EVALUATION REPORT
on
MODIFIED SOLA-VOF CODE
October 18, 1982

For: Grand Gulf Nuclear Station Humphrey Containment Concerns

Subject: Grand Gulf Nuclear Station
Humphrey Containment Concerns

Evaluation Report
on
Modified SOLA-VOF Code

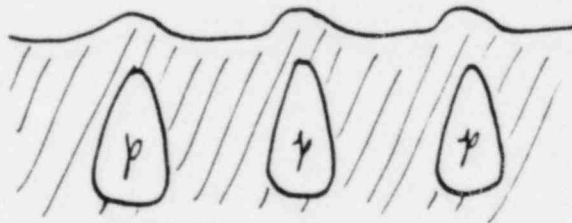
bubbles with the same pressure history. The reason for this is evident from a simple 2D, cross-sectional picture of the two cases:

In the 2D Case the top water layer will accelerate upward uniformly (assuming no variations normal to the page) and no breakthrough will occur! In the 3D Case fluid will be accelerated most above the top of each bubble (where the fluid layer is thinnest). Fluid will also be pushed left and right above each bubble center, allowing the bubbles to deform and push through the surface as shown schematically here:
